RE: Detailed Comment Letter for Copper Flat Copper Mine Draft Environmental Impact Statement (DEIS) in Sierra County, New Mexico

**DETAILED COMMENTS
ON THE
DRAFT ENVIRONMENTAL IMPACT STATEMENT
FOR THE
BUREAU OF LAND MANAGEMENT
COPPER FLAT COPPER MINE PROJECT
IN
SIERRA COUNTY, NEW MEXICO**

Figure 1

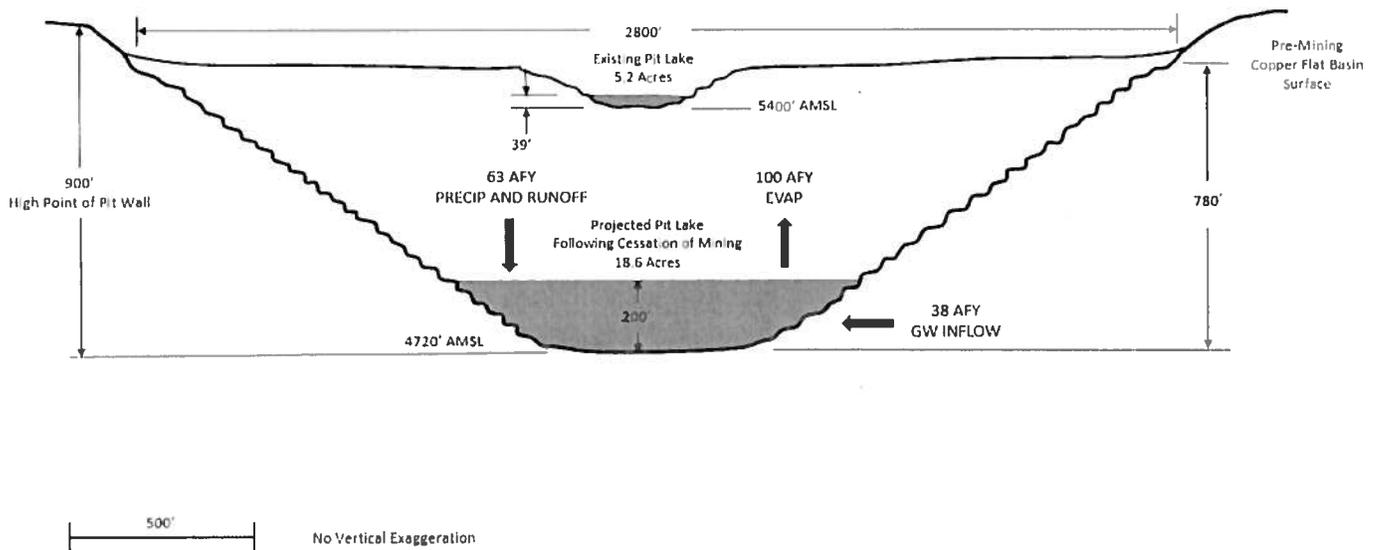
Mine-Specific Comments**1. Section 2.1.1 – Mine Operation – Open Pit, page 2-9:**

EPA recommends including a pit lake conceptual model as a figure in this section like the one shown below in Figure 1. This example illustration was made based on the parameters provided in the DEIS.
